RE: CONCORD AVENUE – WATER MAIN, STREET & SIDEWALK  
RECONSTRUCTION – FILE NO. 5150

ADDENDUM NO. 2

Concord Avenue  
Addendum #2  
February 11, 2010

CITY OF CAMBRIDGE, MASSACHUSETTS CONCORD AVENUE WATER MAIN AND ROADWAY RECONSTRUCTION 0139-68660		SHEET NO. 11		MISCELLANEOUS DETAILS 1		ADDENDUM NO. 2		FIGURE NO. SK-7.1	
DATE 02/11/10

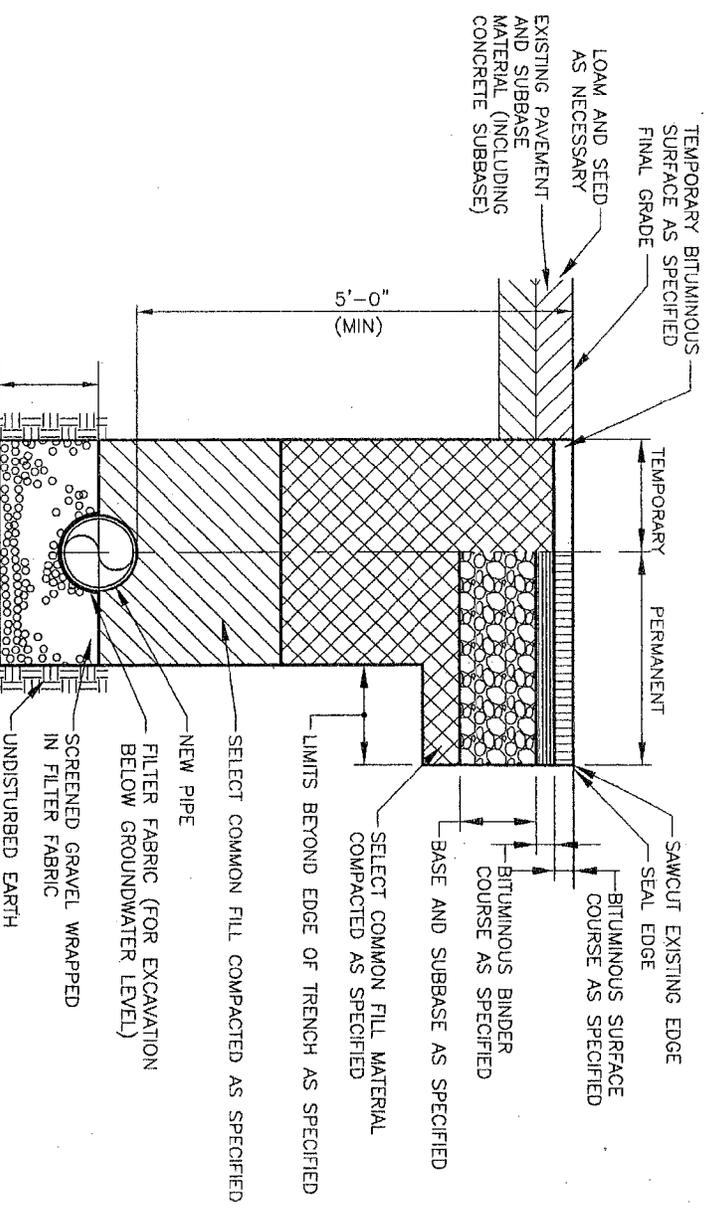
Revise Trench Width pay limit for new 16" DI Water pipe to be maximum 4'-6". Delete the SK-7 "Typical Trench and Pavement Restoration Detail for New 16" DI Water Pipe Along Concord Avenue", in Addendum #1 and replace with attached SK-7.1, Addendum #2, "Typical Trench and Pavement Restoration Detail for New 16" DI Water Pipe Along Concord Avenue"

TRENCH WIDTH  
4'-6" MAX
